GOVERNMENT/INDUSTRY AERONAUTICAL CHARTING FORUM
Instrument Procedures Group
October 25, 2011
HISTORY RECORD

FAA Control # 11-02-297

Subject: Airway "NoPT" Notes on Instrument Approach Procedures

VOR-A
CHESTER(SNC)

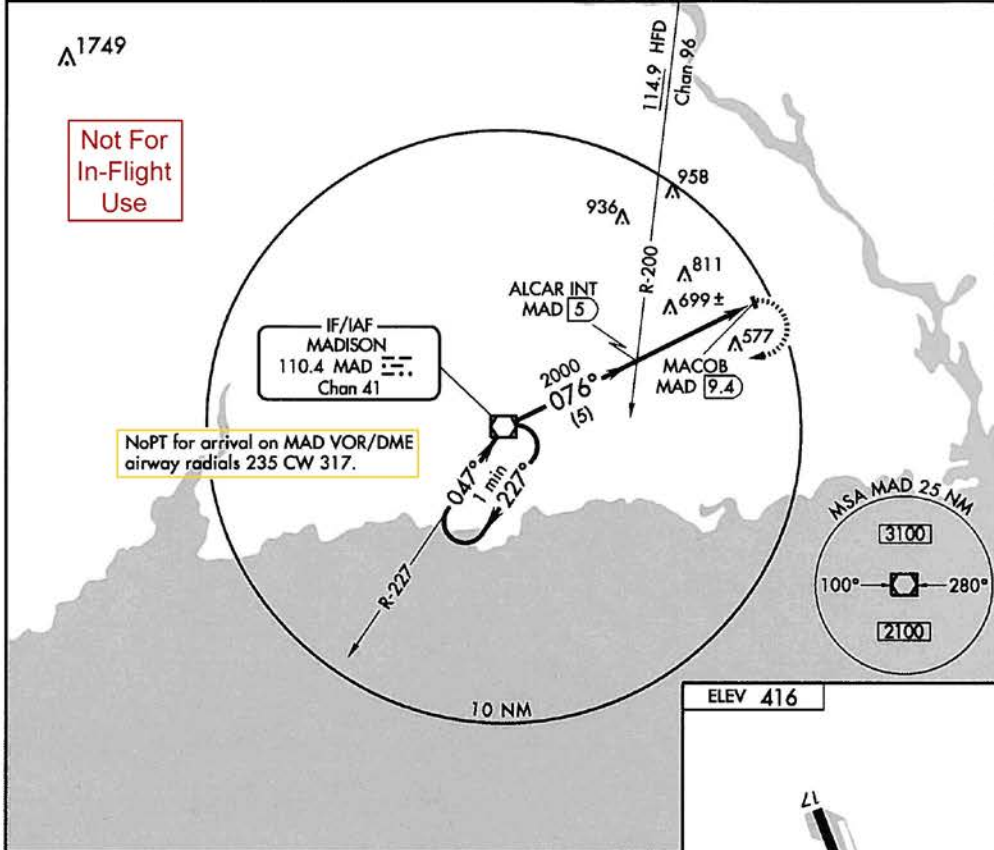
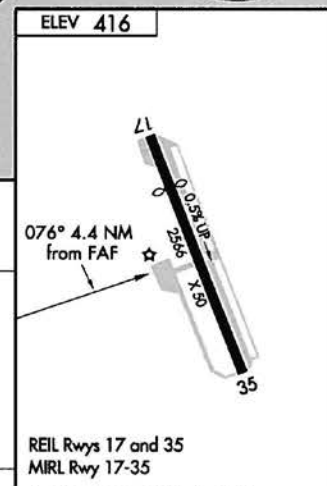
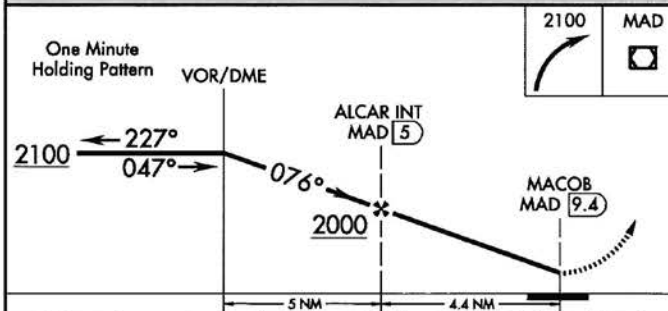
Background/Discussion: Some of the "NoPT" notes on IAP charts are confusing and allow two different interpretations of intent. For example, The note on the Chester, CT (SNC) VOR-A approach states "NoPT for arrival on MAD VOR/DME airway radials 235 CW 317". The note specifies airway radials and Air Traffic expects that aircraft arriving on V-34, V-475, or V-1 from the west comply with the NoPT note and execute a straight in approach. However, the note results in about half of the pilots thinking that it applies to all radials from 235 clockwise to 317. This misinterpretation has been noted in both newly rated and highly experienced pilots.

Recommendations: On the Chester approach note and any other location where ATC wants to apply NoPT only to specific airways, the note must list the specific airway(s) and direction of flight; e.g., "**NoPT for arrival at MAD VOR/DME on V-1 northeast bound, V475 northeast bound, and V-34 southeast bound.**" Additionally enhanced guidance should be placed in the AIM and IPH.
